From: Williams, Jeffrey
Sent: Friday, February 05, 2016 3:04 PM
To: 'Rosario DIMARCO'
Cc: Oswald, Hank
Subject: RE: RE: Dimarco Property Lot N.4
Attachments: 20160205143636058.pdf

ON SITE SEWAGE DISPOSAL SYSTEM DESIGN PLAN

FOR
**RE-BUILDING OF 11410 OLD FREDERICK ROAD
 MARIOTTSVILLE, MARYLAND 21104**

**RE: OSDS Plan Comments
Dimarco Property, Lot 4
Marriottsville, MD 21104**

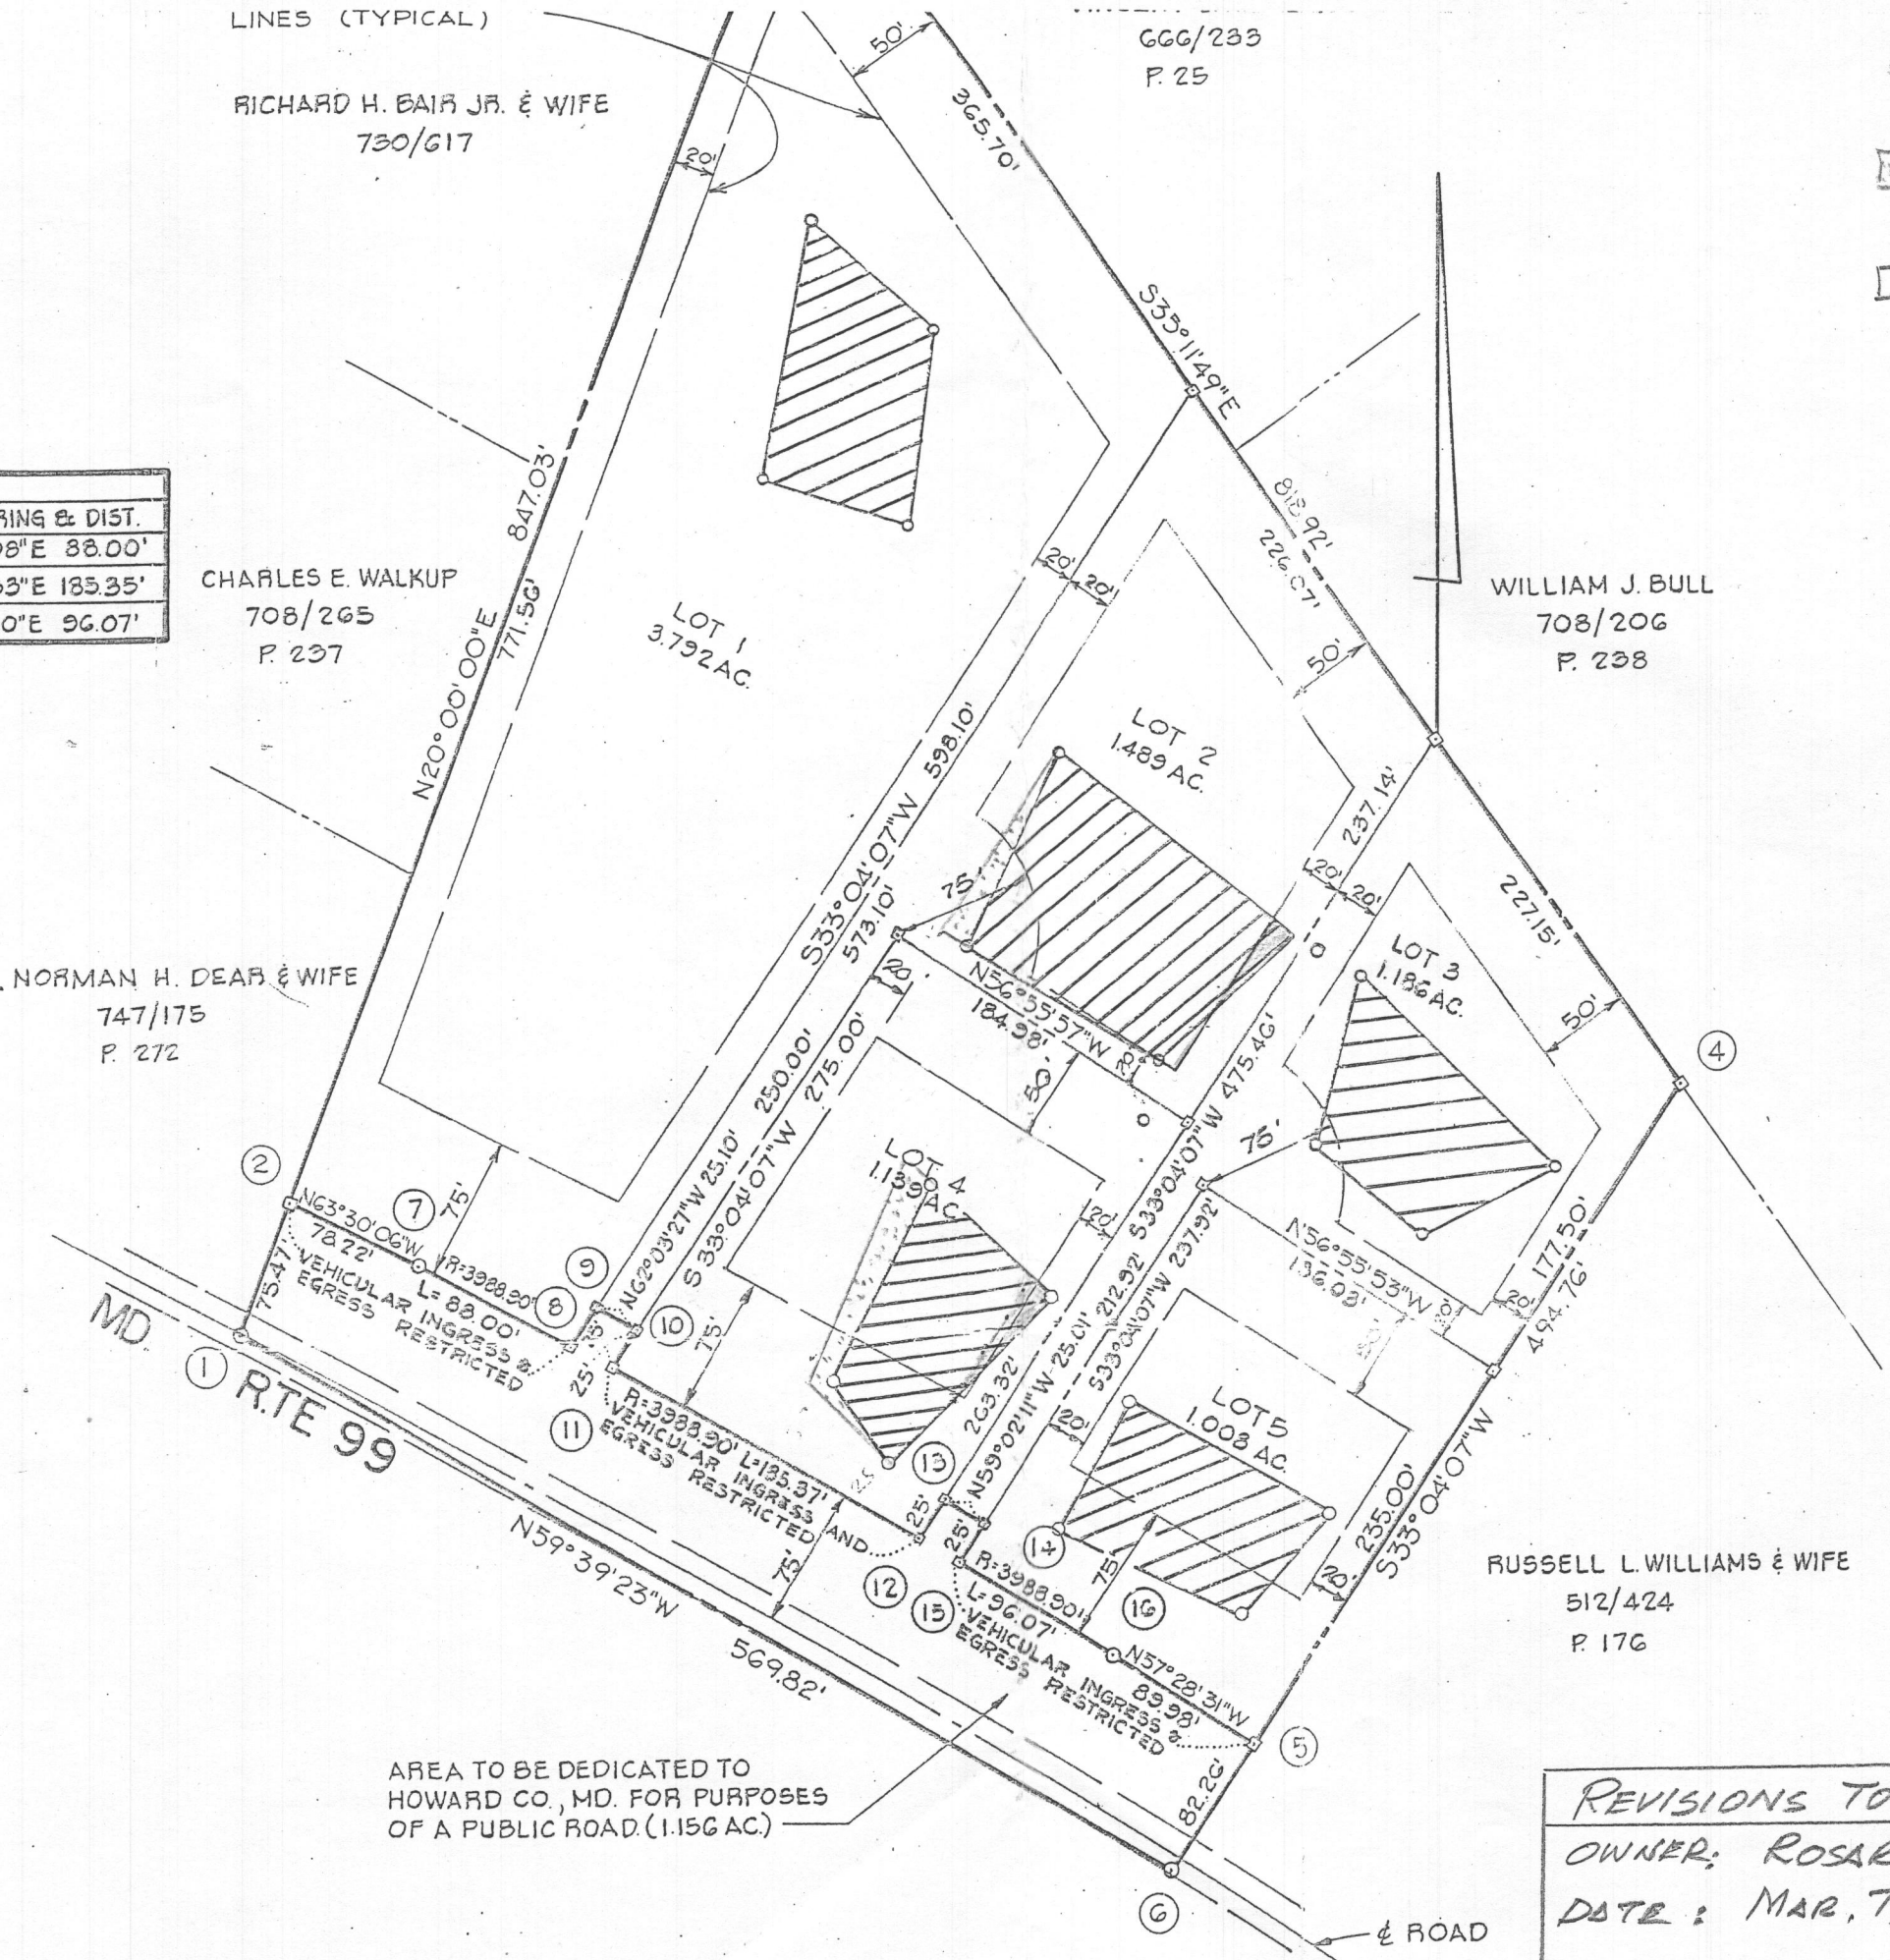
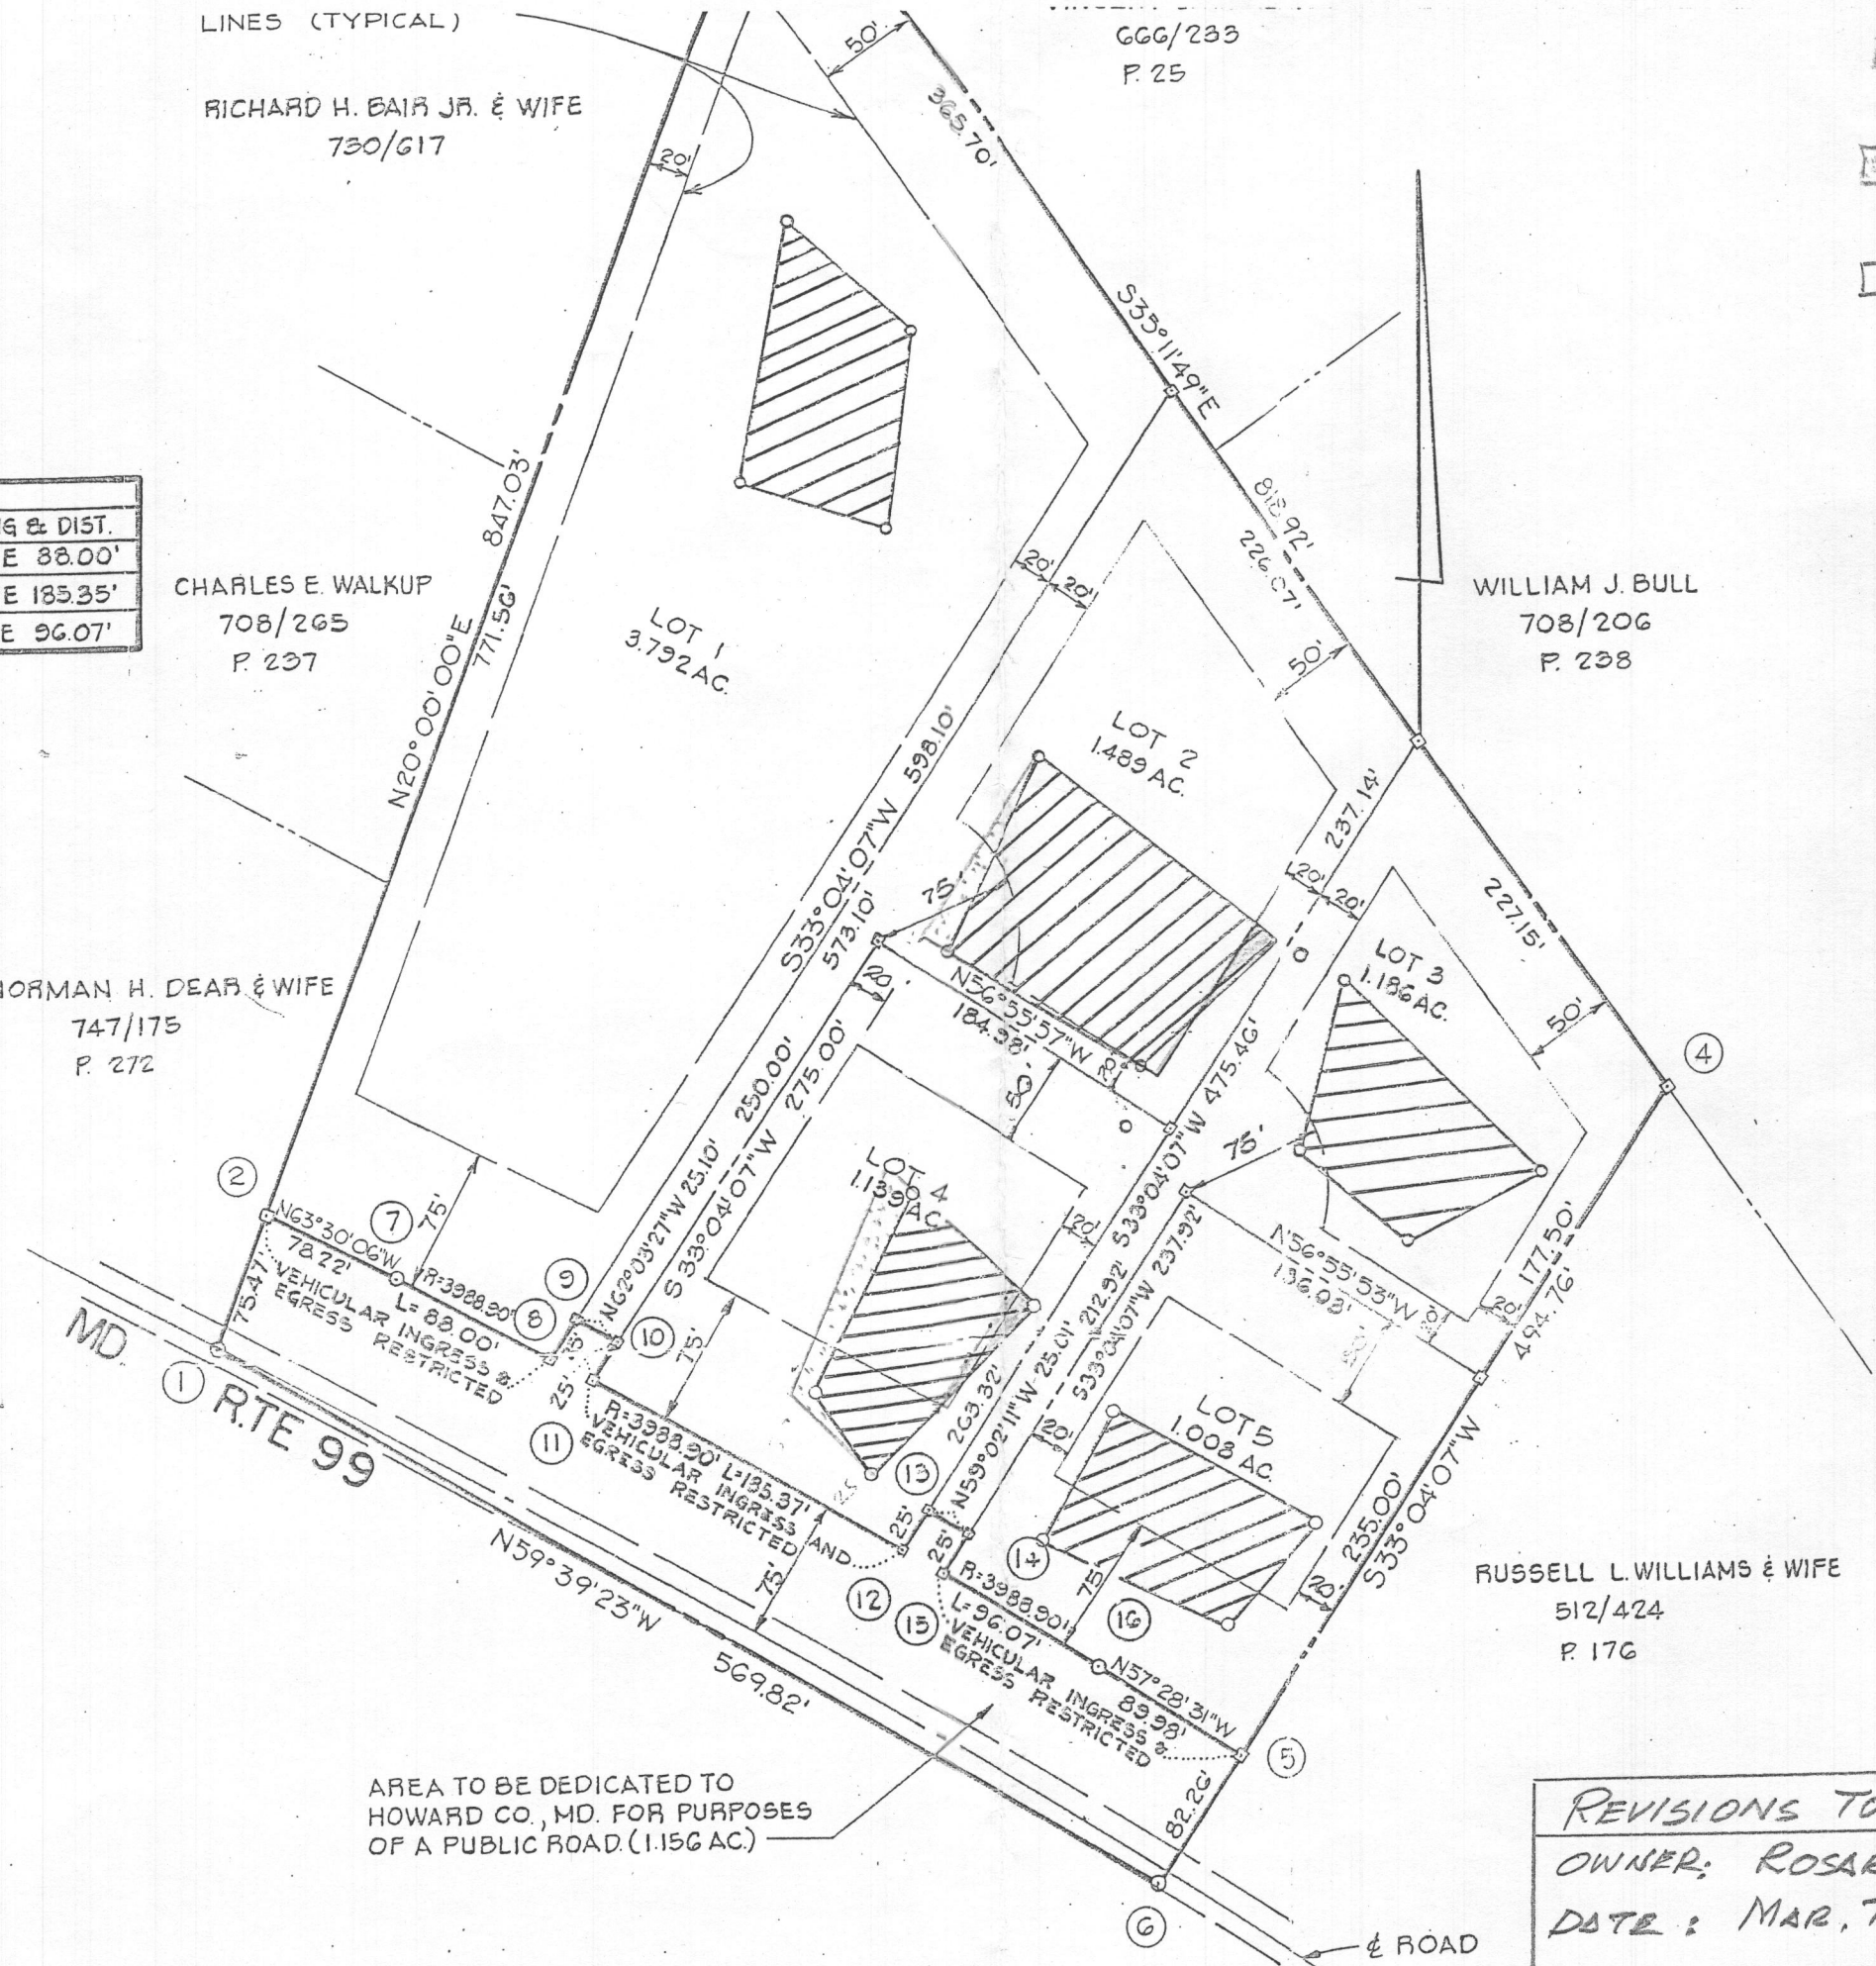
Attached is the water easement location and the field surveyed location of the actual water line. What we want you to do is come in to redline the existing perc cert plan to remove the portion of the sewage disposal areas on lots 4 and 2 that overlap the easement and the portion of lot 4 area that falls within 10' of the water line. At that time, we can figure out the square footage of the area removed and you can redline the area to add it in along the west side and possibly the bottom corner. On lot two, it can be added on the bottom.

- PROPOSED PERC. AREA TO BE REMOVED
- PROPOSED PERC. AREA TO BE ADDED
- PROPOSED 20' PUBLIC WATER EASEMENT.

Alternatively, you can use this attachment to submit a revised perc cert plan for our signature showing the new area along with the water easement and water line.
